Our ref: DOC22/366094 Your ref: SSD-13855453

Grenfell Poultry Breeder Farm – Response to Submissions

Attachment A

Figure 1 Road Design and Access Point Concept Plan (RTS)

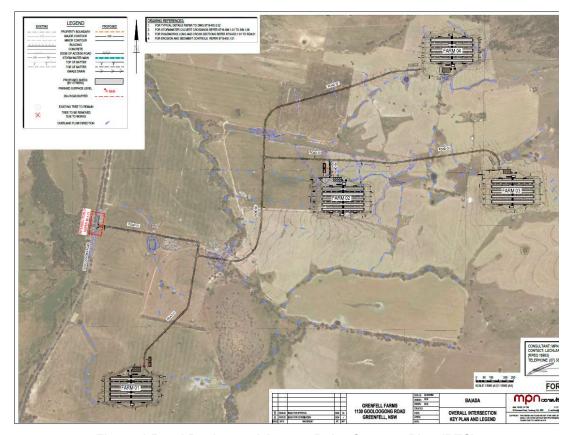
The updated concept plan for the project site submitted by the proponent includes a 25m road buffer and road widening within the site entry point from Gooloogong Road. BCS notes from review of the concept plan that these design changes may require additional clearing of biodiversity values which have not been included within the Biodiversity Development Assessment Report (BDAR) or the projects associated offset calculations.

BCS recommends that both the BDAR and the projects offset calculations are updated to include the abovementioned project design changes. If the total clearing required for the proposed design changes are conceptual and/or uncertain at this point in time, BCS recommends that the upper quantum of vegetation clearing required for the project is assessed and calculated, according to a worst-case scenario.

Figure 2 BDAR Assessment Area (EIS)

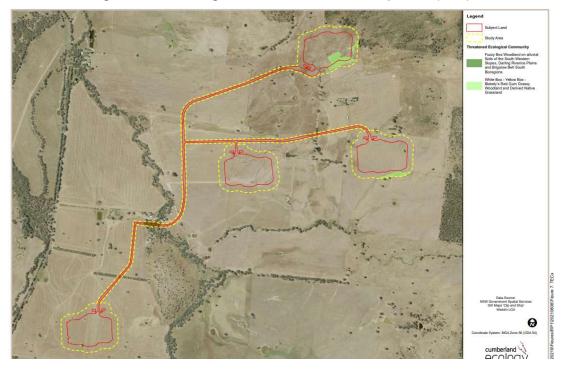
To provide context to BCS concerns an extract of the BDAR detailing the total biodiversity impact assessed within the EIS has been compared against the newly supplied conceptual plan in **Attachment A**. If you require any further information regarding this matter, please contact Ben Ellis, Principal Project Officer, via ben.ellis@environment.nsw.gov.au or (02) 8275 1838.
